Geneva, 11–14 November 2025 Item 4.7.1 of the provisional agenda 1958 Agreement: Consideration of draft amendments to existing UN Regulations submitted by GRSG

Proposal for the 07 series of amendments to UN Regulation No. 46 (Devices for Indirect Vision)

Submitted by the Working Party on General Safety Provisions*

Figure 1a

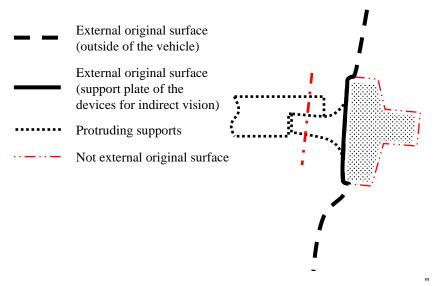
Paragraph 2.7., amend to read:

"2.7. "External original surface" means the outside of the vehicle including the bonnet, the lid of the luggage compartment, the doors, the wings (fender), the roof, the lighting and light-signalling devices, the visible strengthening components, the support plate of devices for indirect vision and additional external original design surfaces defined by the manufacturer excluding protruding supports for devices of indirect vision.

Figures 1 (former), renumber as figures 1b to 1c

Figure 1c

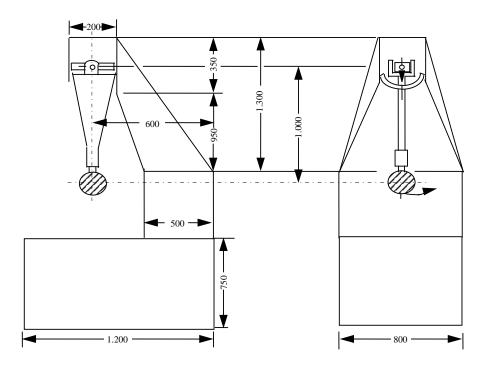
Paragraph 6.3.2.1.1., amend to read:

Figure 1c below gives the dimensions (in mm) of the test rig and the special design specifications:

"6.3.2.1.1. The test rig consists of a pendulum capable of swinging about two horizontal axes at right angles to each other, one of which is perpendicular to the plane containing the "release" trajectory of the pendulum.

The end of the pendulum comprises a hammer formed by a rigid sphere with a diameter of 165 ± 1 mm, and at least on the impact side a 5 ± 1 mm thick rubber covering of Shore A hardness 50.

The end of the hammer may be formed by any other rigid shape having at least on the impact side a spherical shape and a 5 ± 1 mm thick rubber covering of Shore A hardness 50, if the equivalence of this shape is demonstrated through a mathematical model, to the satisfaction of the Type Approval Authority.

Figure 5 **Class II fields of vision**

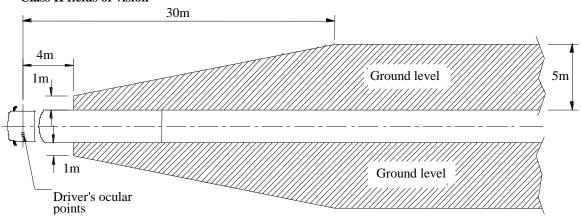
Paragraph 15.2.4.2., amend to read:

In addition, the road shall be visible to the driver over a width of 1 m, which is bounded by a plane parallel to the median longitudinal vertical plane and passing through the outermost point of the vehicle starting from a point 4 m behind the vertical plane passing through the driver's ocular points, while linearly increasing up to a width of 5 m wide at the point 30 m behind the vertical plane passing through the driver's ocular points (see Figure 5).

In addition, the road shall be visible to the driver over a width of 1 m, which is bounded by a plane parallel to the median longitudinal vertical plane and passing through the outermost point of the vehicle starting from a point 4 m behind the vertical plane passing through the driver's ocular points, while linearly increasing up to a width of 5 m wide at the point 30 m behind the vertical plane passing through the driver's ocular points (see Figure 5)."

The field of vision shall be such that the driver can see at least a 5 m wide, flat, horizontal portion of the road, which is bounded by a plane which is parallel to the median longitudinal vertical plane and passing through the outermost point of the vehicle on the driver's side of the vehicle and extends from 30 m behind the driver's ocular points to the horizon.

The field of vision shall be such that the driver can see at least a 5 m wide, flat, horizontal portion of the road, which is bounded on the passenger's side by a plane parallel to the median longitudinal vertical plane of the vehicle and passing through the outermost point of the vehicle on the passenger's side and which extends from 30 m behind the driver's ocular points to the horizon.

Figure 6
Class III fields of vision

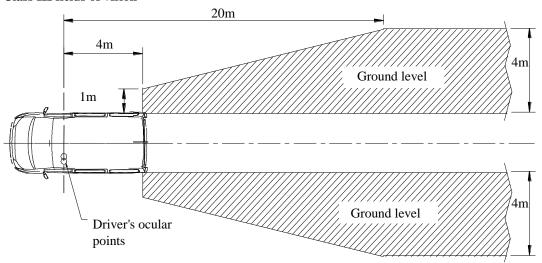
Paragraph 15.2.4.3., amend to read:

The field of vision shall be such that the driver can see at least a 4 m wide, flat, horizontal portion of the road, which is bounded by a plane parallel to the median longitudinal vertical plane and passing through the outermost point of the vehicle on the driver's side of the vehicle and extends from 20 m behind the driver's ocular points to the horizon (see Figure 6).

The field of vision shall be such that the driver can see at least a 4 m wide flat, horizontal portion of the road which is bounded by a plane parallel to the median longitudinal vertical plane passing through the outermost point of the vehicle on the passenger's side and which extends from 20 m behind the driver's ocular points to the horizon (see Figure 6).

In addition, the road shall be visible to the driver over a width of 1 m, which is bounded by a plane parallel to the median longitudinal vertical plane and passing through the outermost point of the vehicle starting from a point 4 m behind the vertical plane passing through the driver's ocular points, while linearly increasing up to a width of 4 m wide at the point 20 m behind the vertical plane passing through the driver's ocular points.

In addition, the road shall be visible to the driver over a width of 1 m, which is bounded by a plane parallel to the median longitudinal vertical plane and passing through the outermost point of the vehicle starting from a point 4 m behind the vertical plane passing through the driver's ocular points, while linearly increasing up to a width of 4 m wide at the point 20 m behind the vertical plane passing through the driver's ocular points."

Figure 7 **Class IV fields of vision**

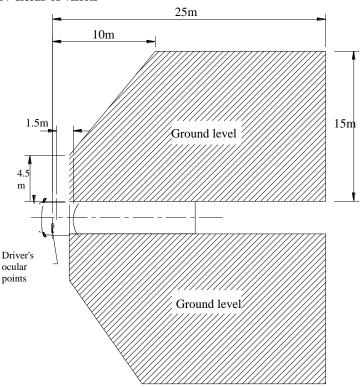
Paragraph 15.2.4.4., amend to read:

In addition, the road shall be visible to the driver over a width of 4.5 m, which is bounded by a plane parallel to the median longitudinal vertical plane and passing through the outermost point of the vehicle starting from a point 1.5 m behind the vertical plane passing through the driver's ocular points, while linearly increasing up to a width of 15 m wide at the point 10 m behind the vertical plane passing through the driver's ocular points (see Figure 7).

In addition, the road shall be visible to the driver over a width of 4.5 m, which is bounded by a plane parallel to the median longitudinal vertical plane and passing through the outermost point of the vehicle starting from a point 1.5 m behind the vertical plane passing through the driver's ocular points, while linearly increasing up to a width of 15 m wide at the point 10 m behind the vertical plane passing through the driver's ocular points (see Figure 7)."

The field of vision shall be such that the driver can see at least a 15 m wide, flat, horizontal portion of the road, which is bounded by a plane parallel to the median longitudinal vertical plane of the vehicle and passing through the outermost point of the vehicle on the driver's side and which extends from at least 10 m to 25 m behind the driver's ocular points.

The field of vision shall be such that the driver can see at least a 15 m wide, flat, horizontal portion of the road, which is bounded by a plane parallel to the median longitudinal vertical plane of the vehicle and passing through the outermost point of the vehicle on the passenger's side and which extends from at least 10 m to 25 m behind the driver's ocular points.
